PRODUCT RETROFIT NOTICE**3M™ DBI-SALA ADJUSTABLE BARREL MOUNT DAVIT SLEEVE (OSHA& CE)**

The 3M™ DBI-SALA Adjustable Barrel Mount Sleeve is a portable, tool-free base, designed for manhole and confined space entry/retrieval applications.

Mango de montaje de barril regulable para pescante

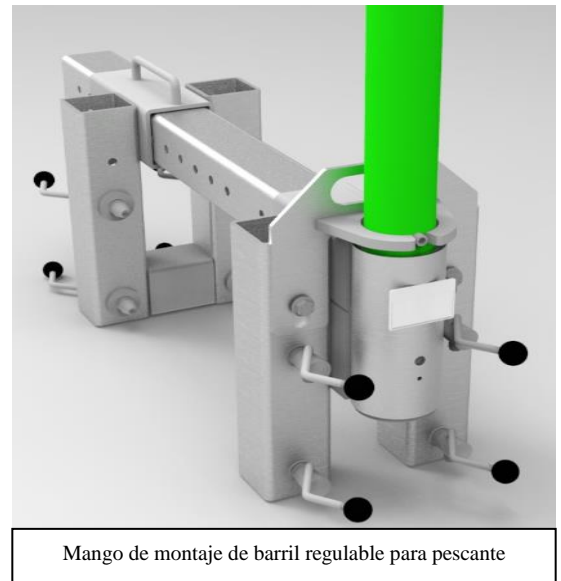
3M Fall Protection ha determinado que los montajes de barril no cumplen por completo con todas las afirmaciones en cuanto a la carga nominal en todas las posiciones de ajuste, según se indica en el manual “Instrucciones de uso” (Instruction for Use, IFU), así como en las etiquetas de los productos. No se han registrado accidentes o lesiones relacionados con este problema. El problema afecta solo a los siguientes números de modelo/pieza identificados en las etiquetas de productos de las unidades: 8512285, 8562285, 8510715 y 8516088.

Para resolver el problema, 3M Fall Protection ha desarrollado una modificación en el diseño de un componente del montaje de barril. Esta modificación limitará el ajuste del brazo del pescante a la posición perpendicular cuando se use para la detención de caídas. Para aplicaciones de rescate, el rango de ajuste completo de hasta 180 grados no resulta afectado. Además, la modificación en el diseño ha reducido la capacidad nominal (carga de trabajo) del montaje de barril a 140,6 kg (310 lb) por usuario. La modificación está incorporada en todos los sistemas fabricados después del 10 de noviembre de 2017 y estará disponible como reconversión sin costo alguno para todos los usuarios finales que hayan adquirido sus sistemas antes del 10 de noviembre de 2017.

Usuarios finales: Si tiene una de las unidades afectadas, comuníquese con el Departamento de Servicio al Cliente al 800-328-6146 (extensión 2012) o envíe un correo electrónico a 3MUSFPServiceAction@mmm.com para recibir el kit de reconversión sin cargo. Número de pieza del kit de reconversión: 8547945. Si nos envía su información de contacto, su dirección de envío y los detalles de pieza/modelo del producto, le enviaremos el kit de reconversión sin cargo. Cuando reciba el kit, descargue el manual IFU actualizado desde <http://capitalsafety.webdamdb.com/viewphoto.php?&albumId=562594&imageId=15807097>.
